BIDDERS BULLETIN

PROJECT: Brodstone Memorial Hospital
Specialty Clinic & PT Pool Additions
Superior, Nebraska

BB-1

DATE ISSUED: April 4th, 2016

DATE: 4-4-2016
DRAWING: A1021a
FROM SHEET: A1021

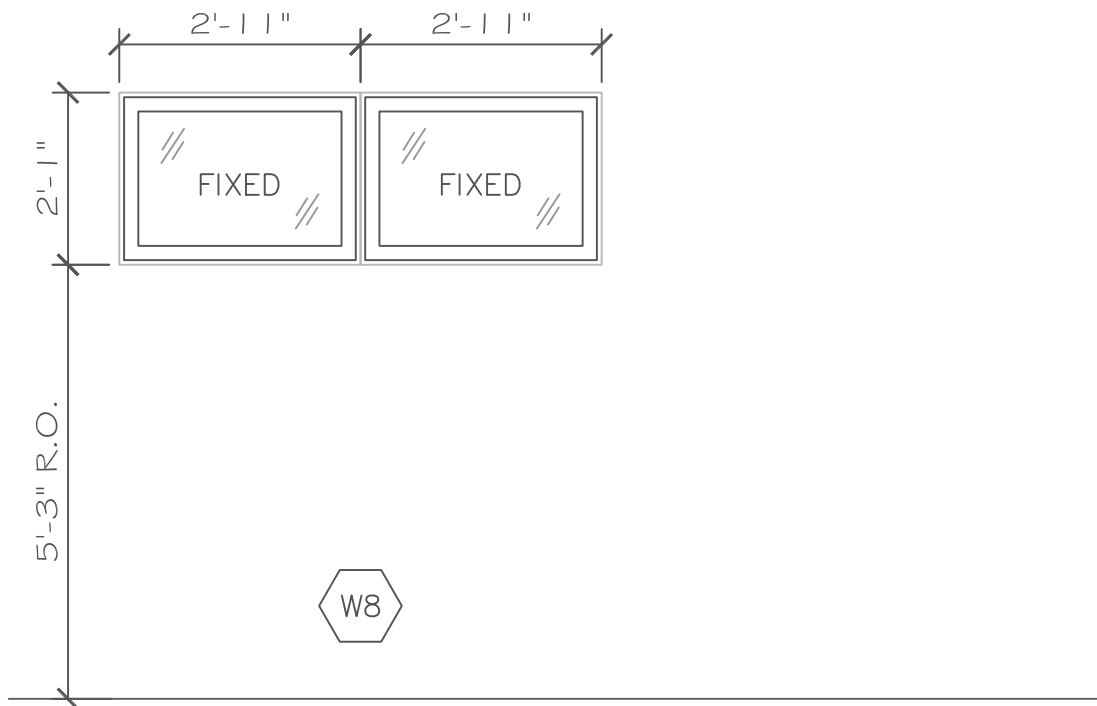
*Add window type W8 elevation. See attached drawing A1021a

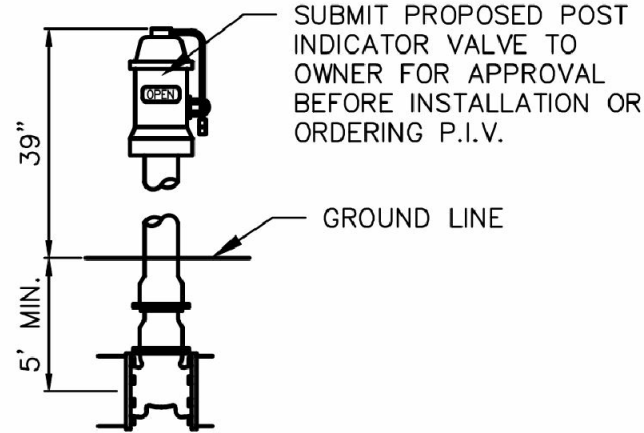
- 1. Sheet M001 Site Plan Mechanical: A. Tie new 6” fire service into existing 8” main and extend to clinic addition as shown on attachment 1M. Install PIV as shown, see Post Indicator Valve Detail on attachment 1M.
2. Sheet M500 Fire Sprinkler Plan: A. Bring in 6” fire service into clinic basement Storage 2 A003, see attachment 2M. See fire service riser detail shown on attachment 2M. Extend fire department connection as shown on attachment 2M up through chase on first floor.
3. Sheet M110a Lower Level Area “A” Sanitary, Waste & Vent: A. Extend 4” waste to Storage 2 A003 in clinic addition to location shown on attachment 3M. Install floor drain (FD-1) as shown on attachment 3M for fire service riser. Install 2” vent as shown on attachment 3M.

16. TIE NEW 6" FIRE SERVICE INTO EXISTING 8" WATER MAIN FOR NEW ADDITION. INSTALL POST INDICATOR VALVE AS SHOWN, SEE DETAIL SHOWN ABOVE. SEE SHEET M500 FOR CONTINUATION.

E101a

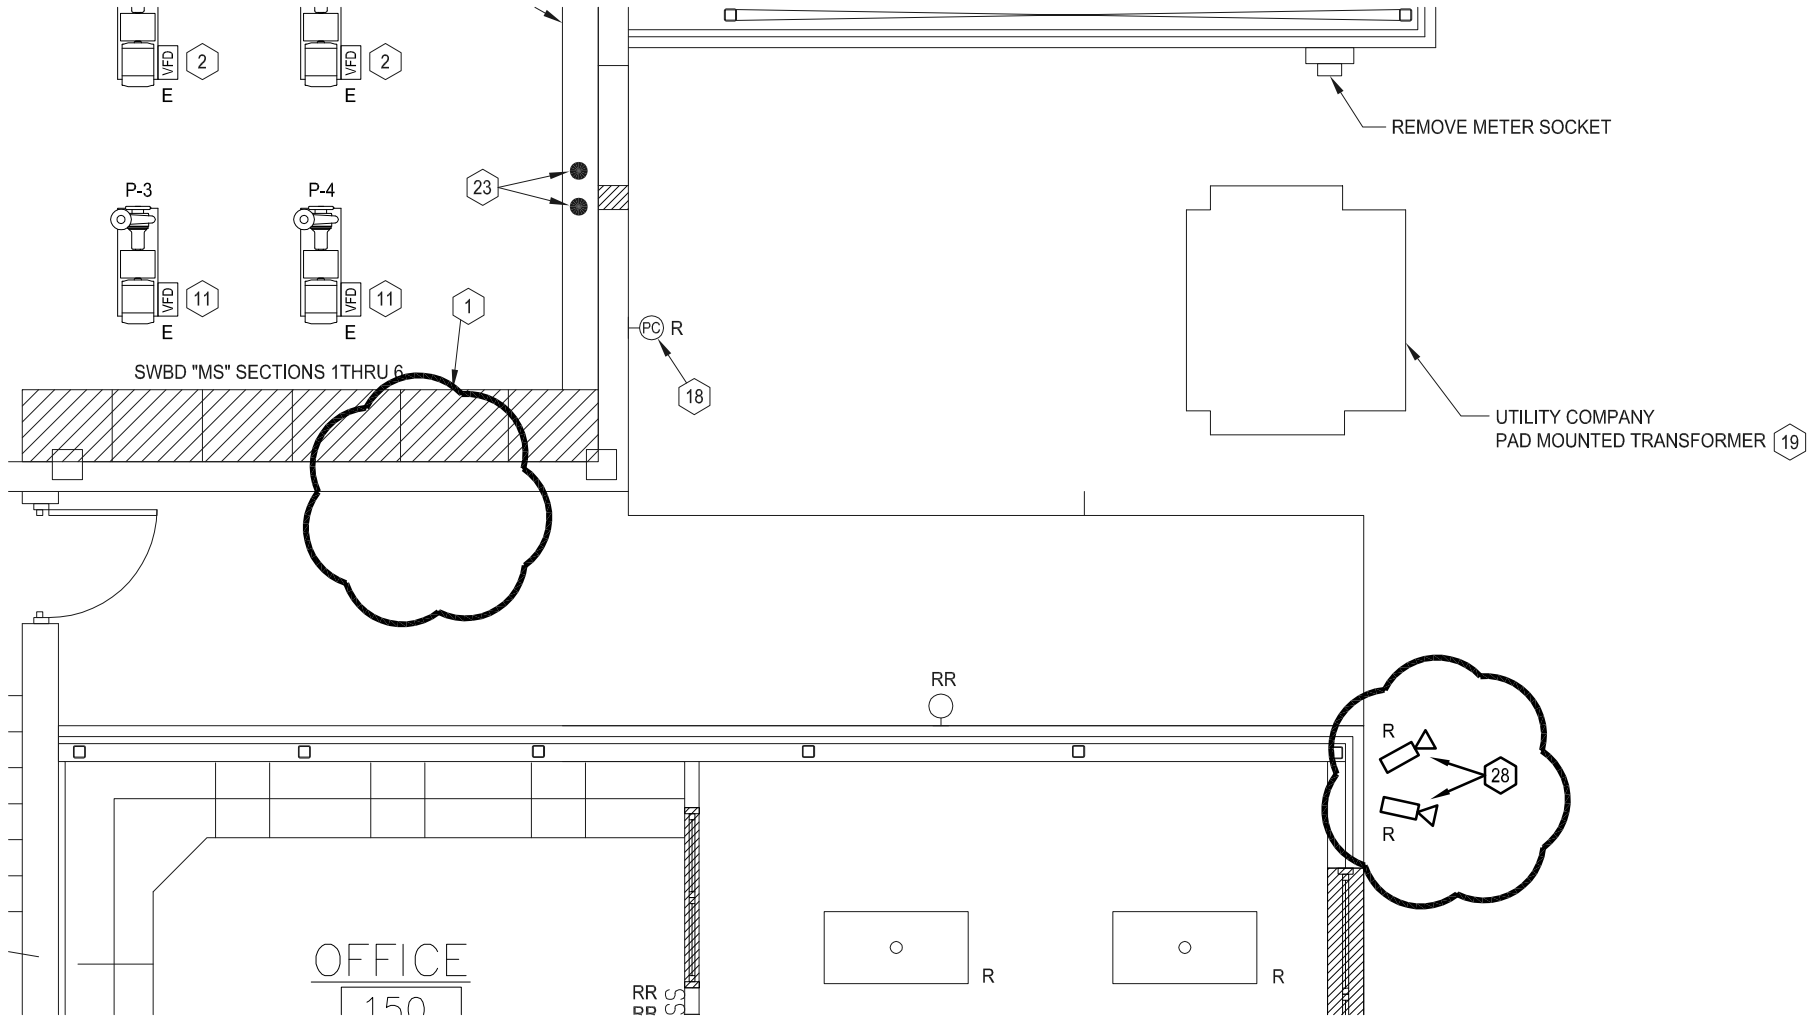
2. Sheet E101a:
 - A. Stairs 179: Remove existing wall heater, conduit and conductors back to its source above south door in Stairs 179. See attached Sheet E101a Attachment No. 1.

E101d

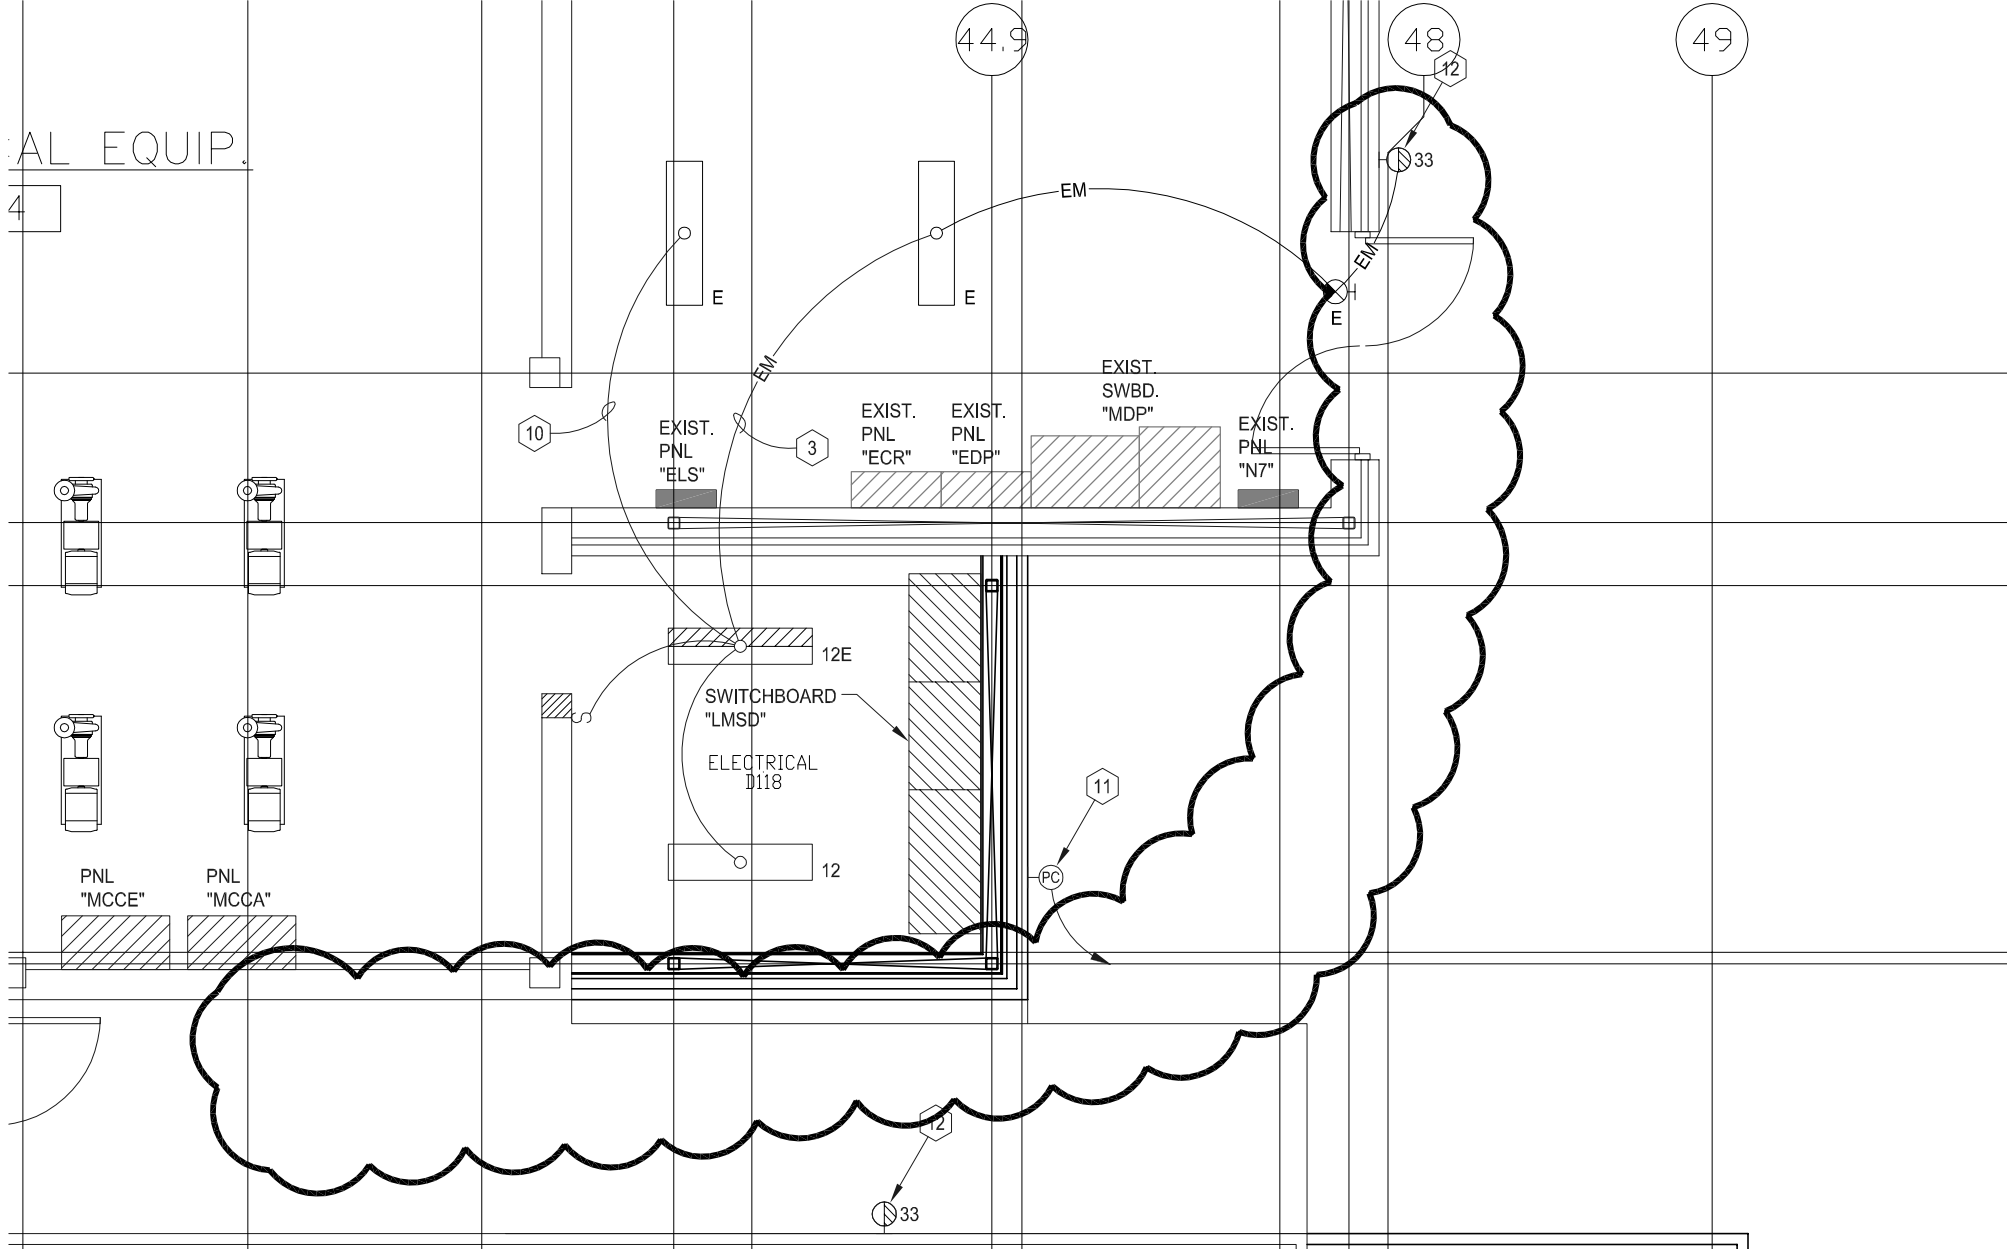
3. Sheet E101d:
 - A. Remove (2) existing cameras on east exterior wall. Return to Owner. See attached Sheet E101d Attachment No. 1.
 - B. Delete exterior light fixture shown on south exterior wall of Mechanical Equipment 154. Light fixture does not exist. See attached Sheet E101d Attachment No. 1.
